**STATE OF CONNECTICUT  
CONNECTICUT SITING COUNCIL**

EVERSOURCE ENERGY APPLICATION FOR A CERTIFICATE OF ENVIRONMENTAL COMPATIBILITY AND PUBLIC NEED FOR THE CONSTRUCTION, MAINTENANCE, AND OPERATION OF A 115-KILOVOLT (KV) BULK SUBSTATION LOCATED AT 290 RAILROAD AVENUE, GREENWICH, CONNECTICUT, AND TWO 115-KV UNDERGROUND TRANSMISSION CIRCUITS EXTENDING APPROXIMATELY 2.3 MILES BETWEEN THE PROPOSED SUBSTATION AND THE EXISTING COS COB SUBSTATION, GREENWICH, CONNECTICUT, AND RELATED SUBSTATION IMPROVEMENTS.

DOCKET NO. 461A

**TOWN OF GREENWICH WRITTEN COMMENTS TO DRAFT FINDINGS OF FACT**

46. A simplified line drawing of the existing Greenwich area electric system is presented below:

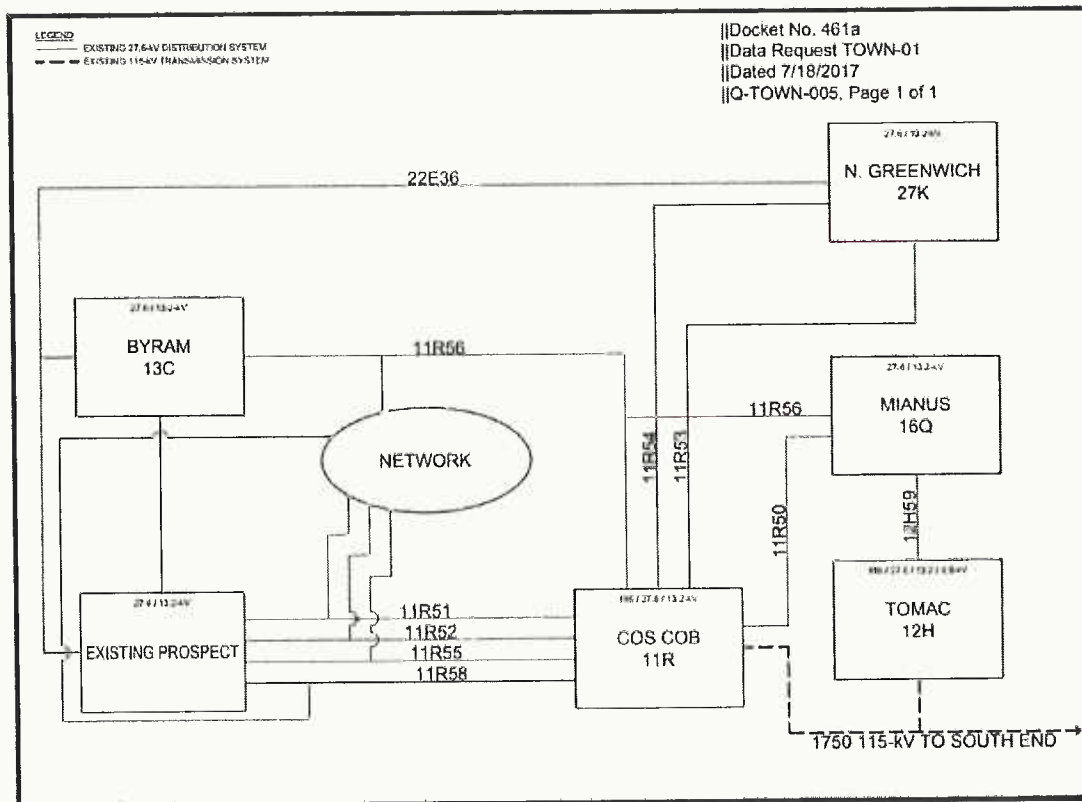
**Comment:** The diagram is incomplete and inconsistent with the record as it does not depict the lines that feed the eleven large industrial and commercial customers who are served at 27.6-kV. (Council Admin. Notice 43, Eversource 1, p. E-3; Eversource 9, Resp. to Q-TOWN-020; Eversource 14, Resp. to Q-TOWN-076; 8-29-17 Tr. pp. 61-63).

75. The Modified GSLP would establish a new 115-kV to 13.2-kV substation west of Indian Harbor (Greenwich Substation), and a new 115-kV transmission line connection between the existing Cos Cob Substation and the new Greenwich Substation, as shown below:

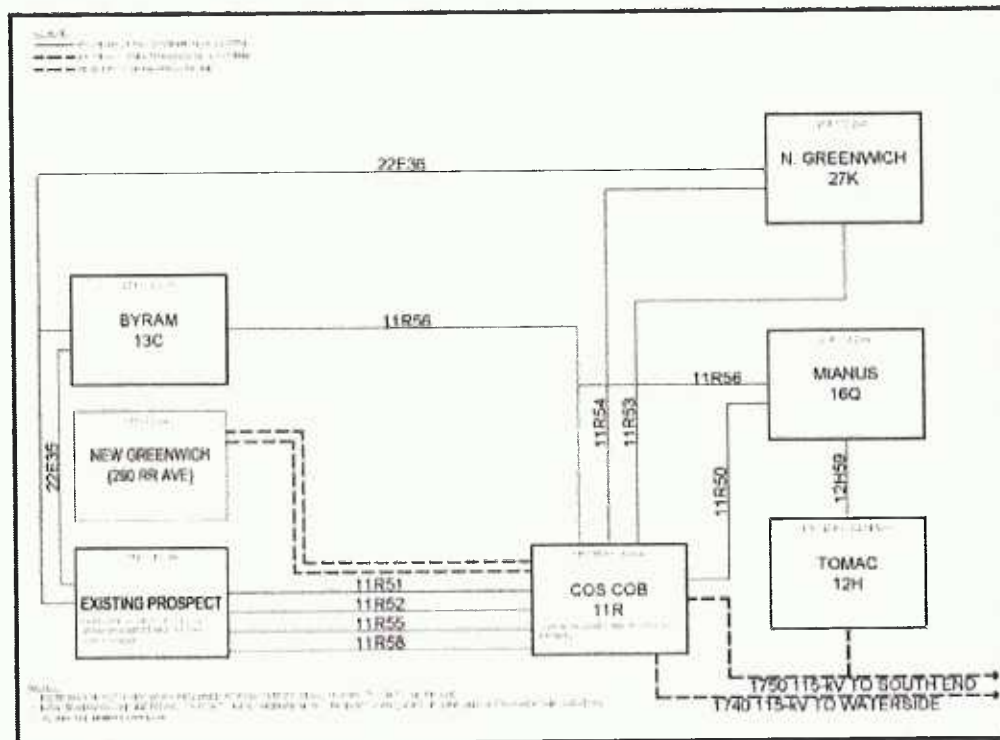
**Comment:** The diagram is incomplete because it does not depict the 27.6-kV lines that feed the eleven commercial and industrial customers and the Greenwich Network, all of whom will continue to be served at 27.6-kV even if the Modified GSLP is approved. (Council Admin. Notice 43, Eversource 1, p. E-3; Eversource 9, Resp. to Q-TOWN-020; Eversource 14, Resp. to Q-TOWN-076; 8-29-17 Tr. pp. 61-63).
